R24CW

DATE: January 9, 2025
TO: Blue Bird Owners
Subject: R24CW: Park Brake Hand Lever Secondary Latch

IMPORTANT SAFETY RECALL

SUBJECT: R24CW: Park Brake Hand Lever Secondary Latch

Figure 1

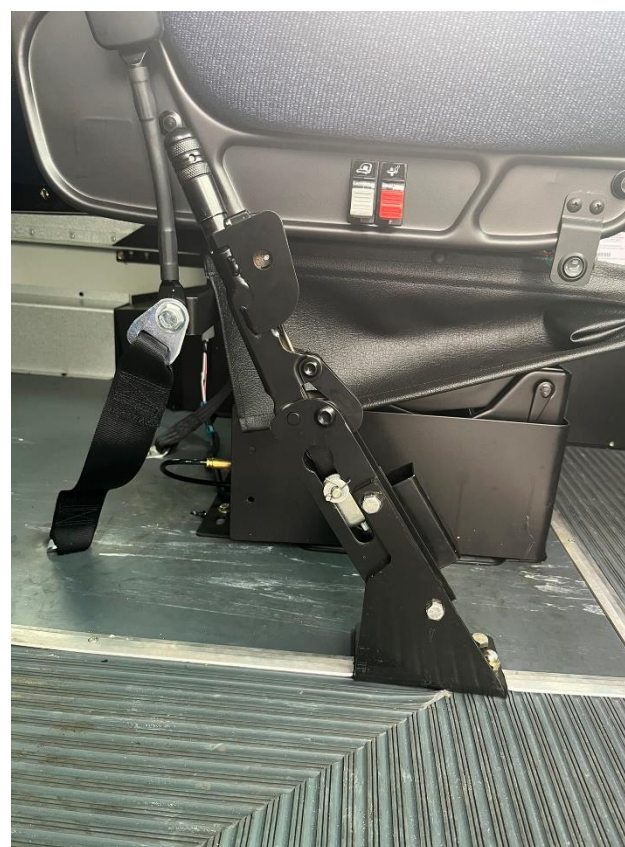
1. Ensure lever (aka handle) is in the applied position. (Figure 1)
2. Apply 8 lbs. of force to handle without pressing secondary release. (Figure 2)
3. Repeat step # 2 two additional times.
4. If handle does NOT go into unapplied position any of the 3 rounds of test application (steps # 1 – 3), return bus to service.
5. If handle does move into the unapplied position during any of the 3 rounds of test application, replace lever assembly (Part # 10050455).
